# SCHMIDT PROPERTY RM-30 MAP AMENDMENT

## LETTER OF INTENT

N.E.S. Inc. on behalf of Turkey Canon Quarry Inc requests approval of a Map Amendment (Rezoning) from RR-5 CAD-O to RM-30 CAD-O (26.7482 Acres).

PCD File No. P-22-022

## LOCATION

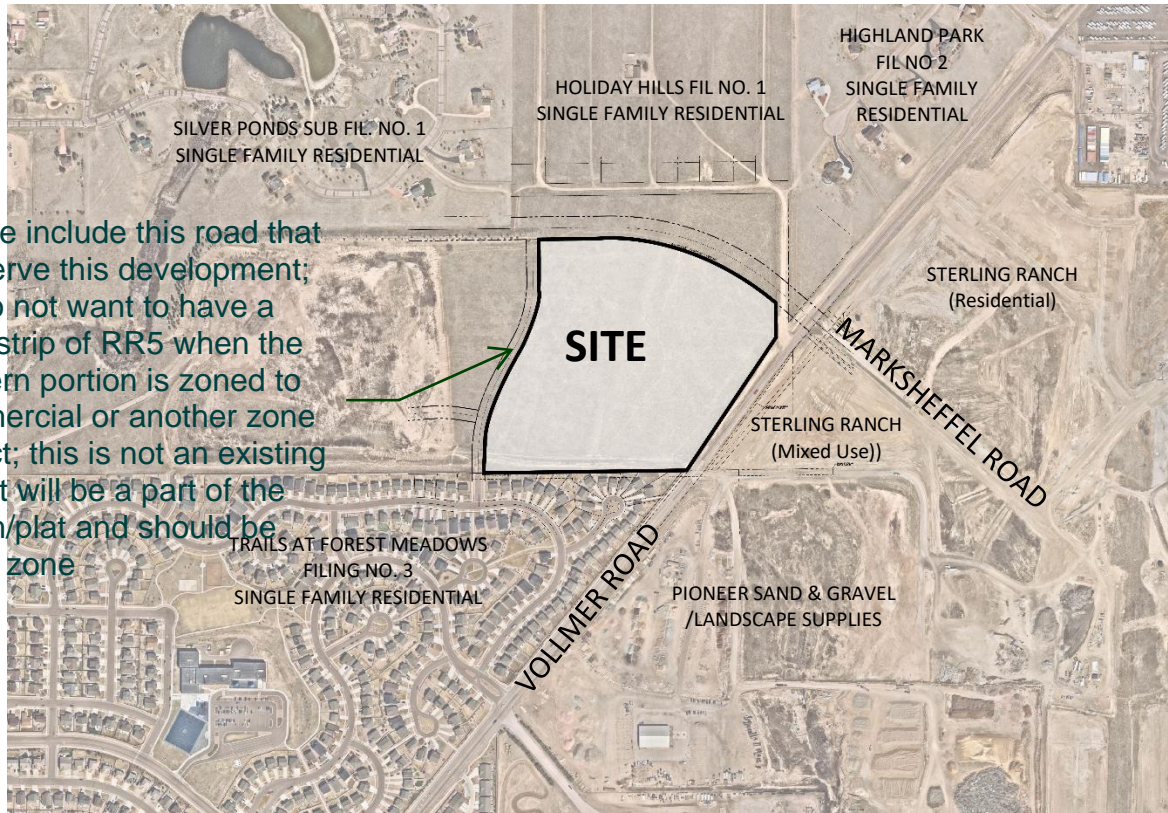
Please include this road that will serve this development; we do not want to have a spite strip of RR5 when the western portion is zoned to commercial or another zone district; this is not an existing road it will be a part of the prelim/plat and should be same zone

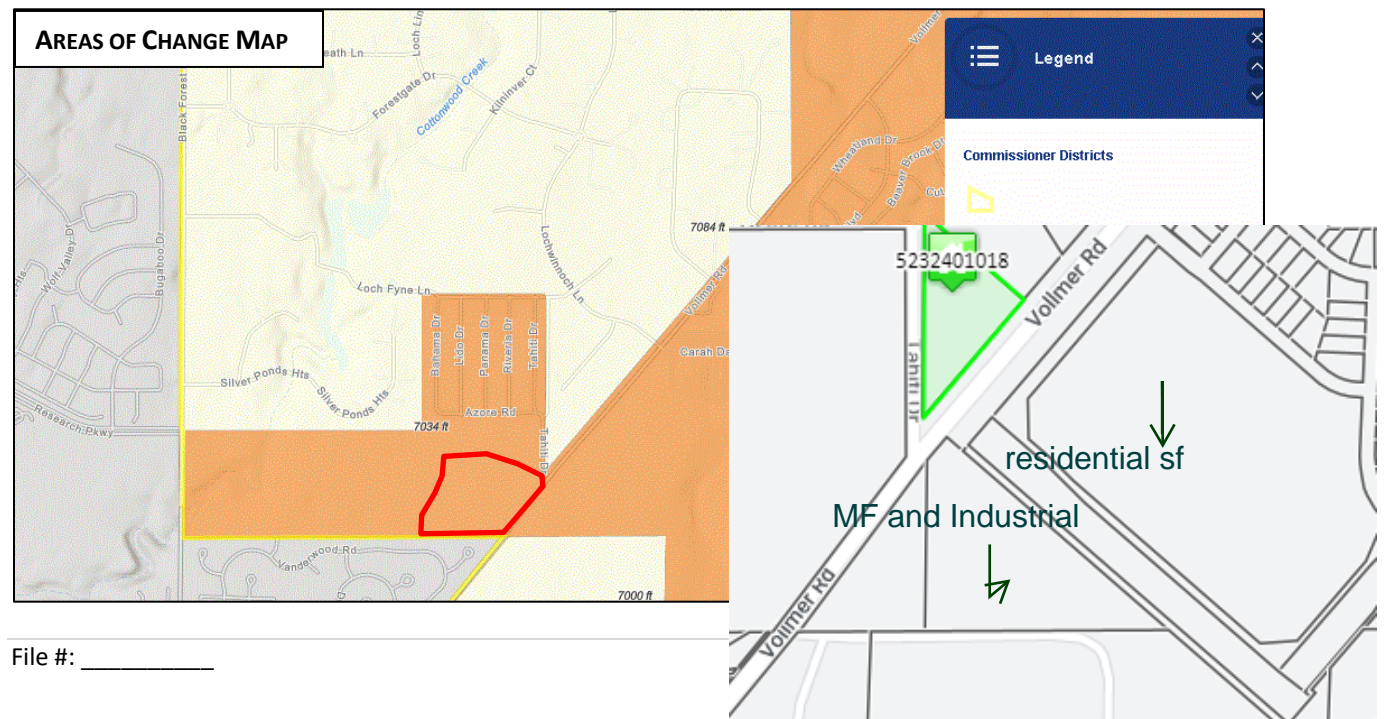
residential sf

MF and Industrial
